Project: DSC Ref: CA 2025_5878/1, Resort Complex, 18 Oasis Drive, Wonga Beach

Subject: Submission regarding desirability of Road Reserve widening for future benefit to Wonga Beach community.

7.2 823.22 LR1.A Link Road Proposal 1

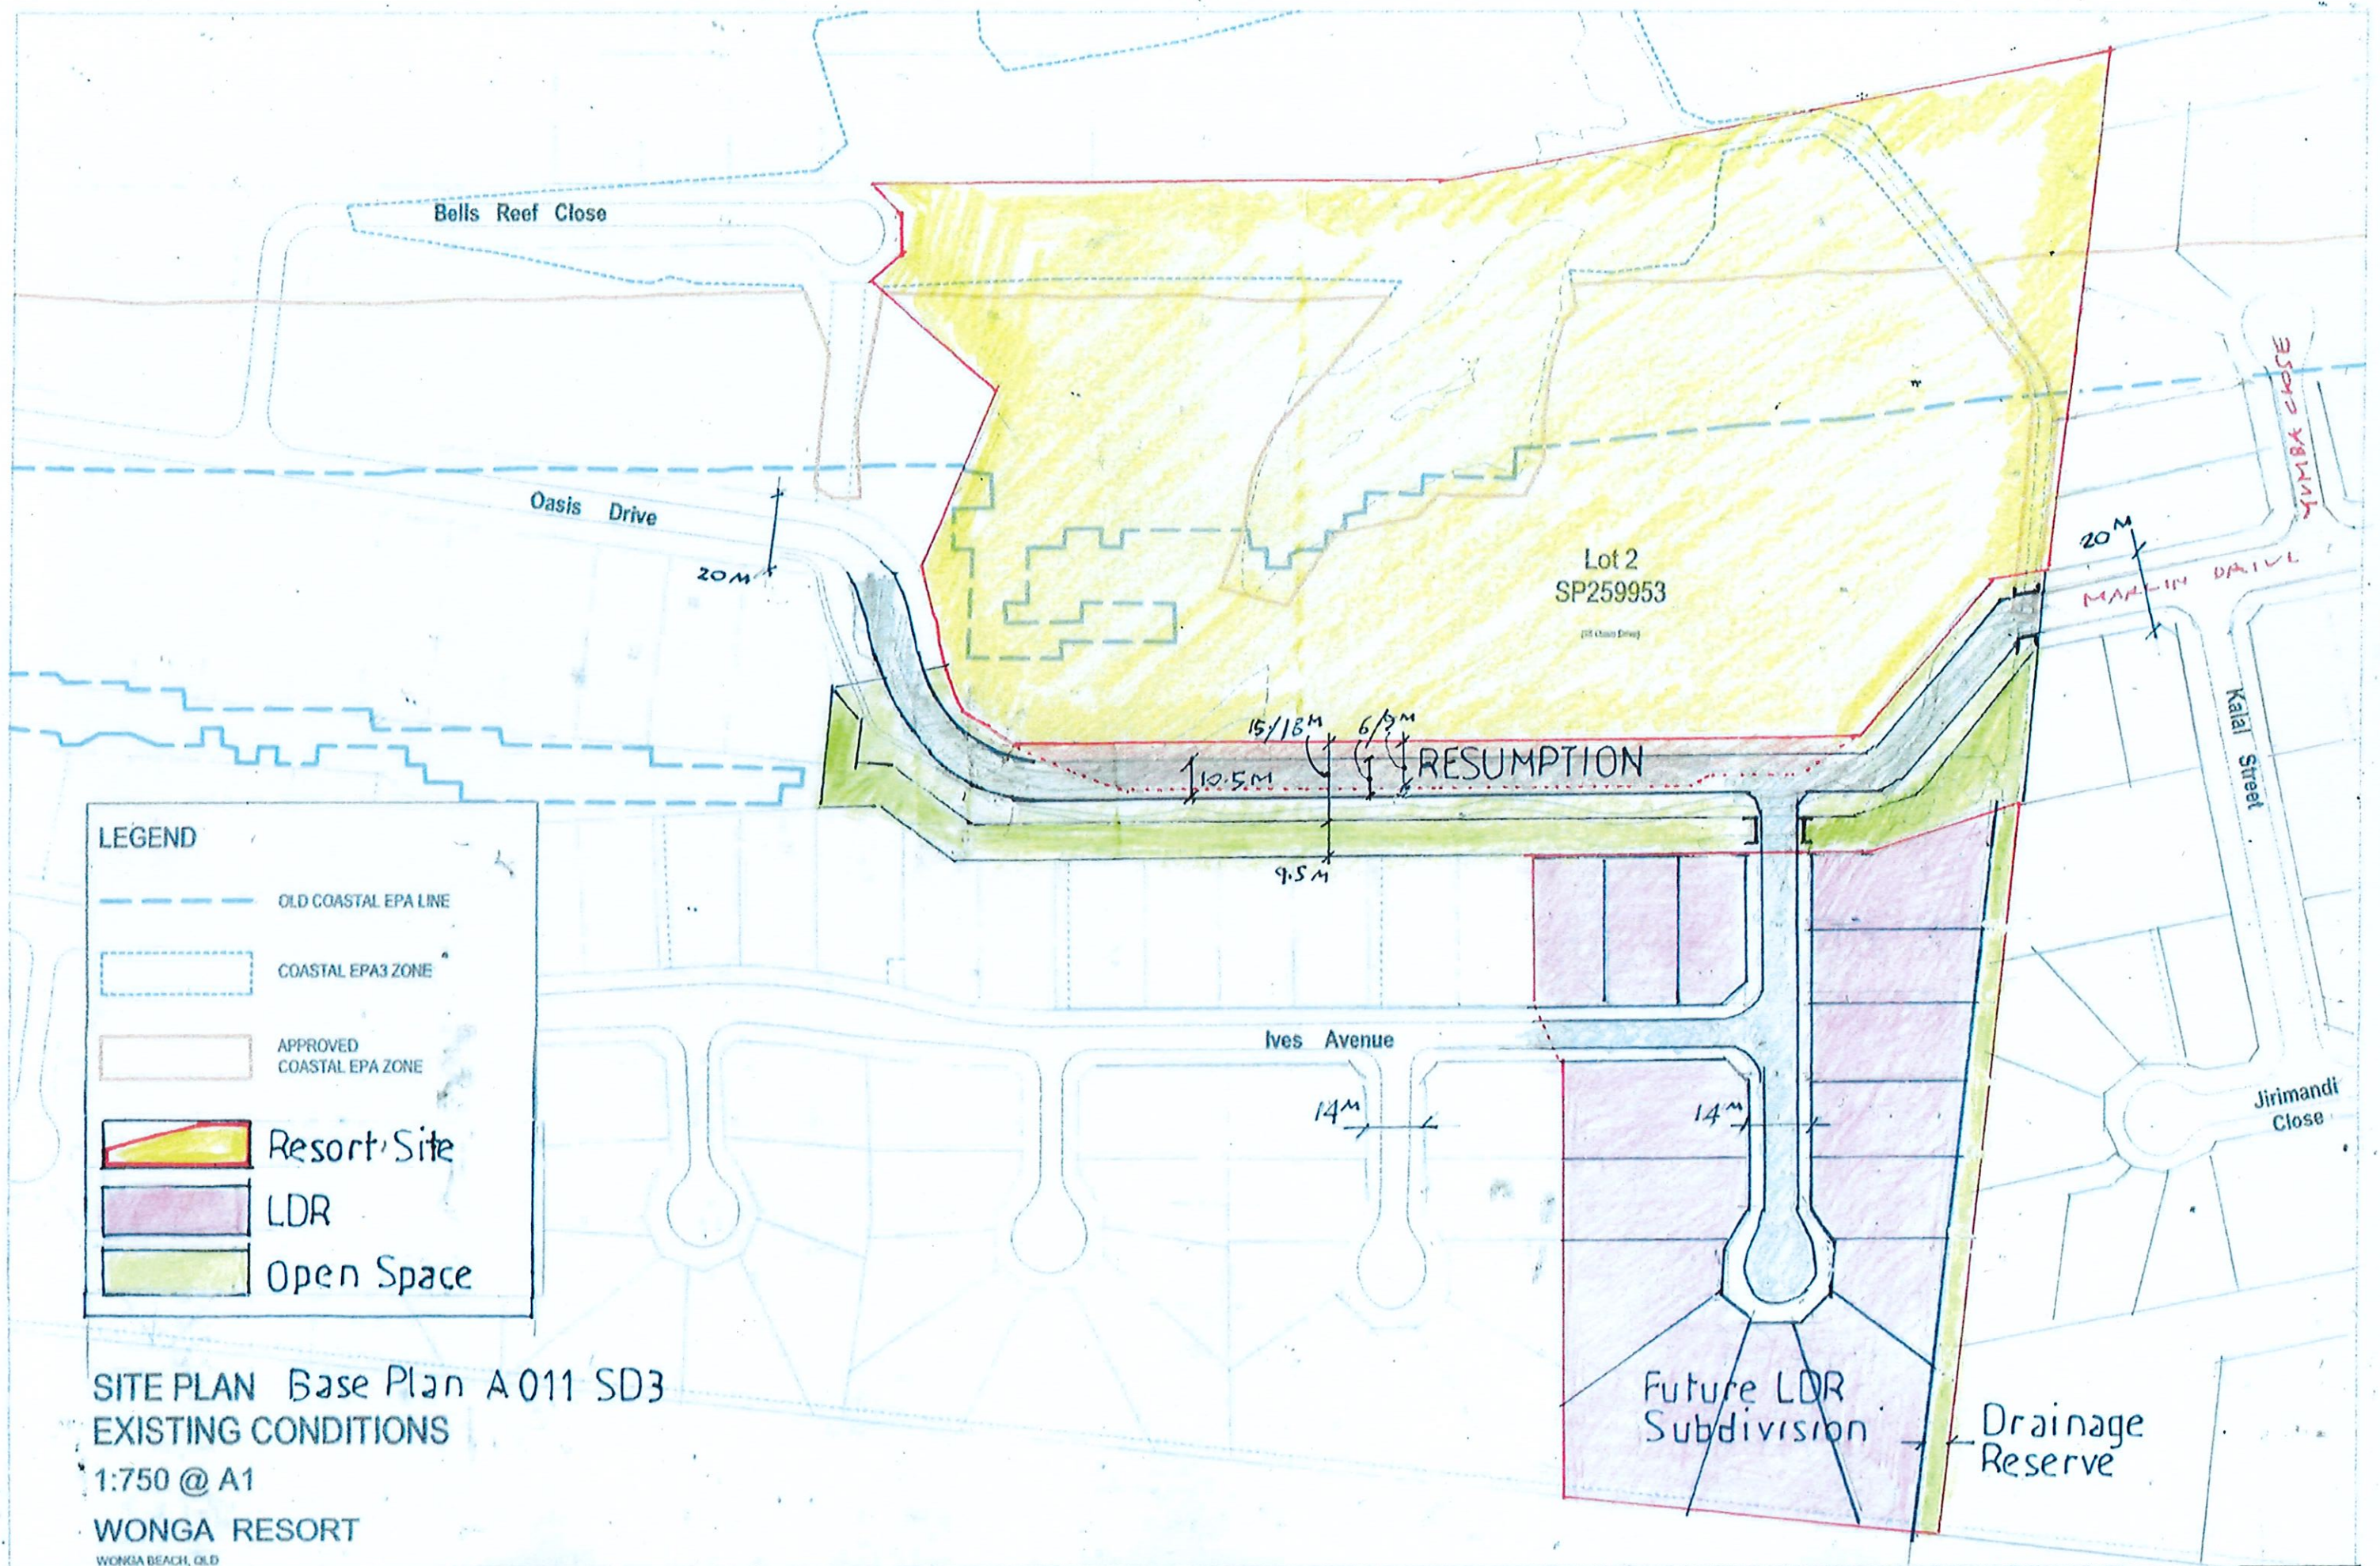
This plan explores the impact of a 6m road widening on the current footprint of the resort complex as shown on DA drawings. It assumes that if the Link Road existed, it would be possible to separate the Guest Access point from the Service Access point to the benefit of on-site traffic circulation (about 50m apart). Minor modification of the configuration of the Vehicular Ramp to Level 1 Entry Roundabout would be necessary to improve the grade of this Ramp, and a more direct access from the Guest Access point to the Undercroft road system could be achieved.

The Service Access point would lead directly into the Undercroft area, and slight reduction in the diameter of the Roof Overhang above the roundabout areas would be needed to avoid encroachment into the Road Reserve. The setbacks to roof overhangs to western Villas fronting the road reserve would need to be reduced which would require Council to relax front setbacks, to enable the current footprints of the Resort Complex to be maintained.

For a 9m or 11m road reserve widening to be achieved, some redesign would be necessary to reduce the internal Courtyard spaces and the Racetrack Undercroft Driveway and Elevated Walkway widths between the East and West villas building footprints.
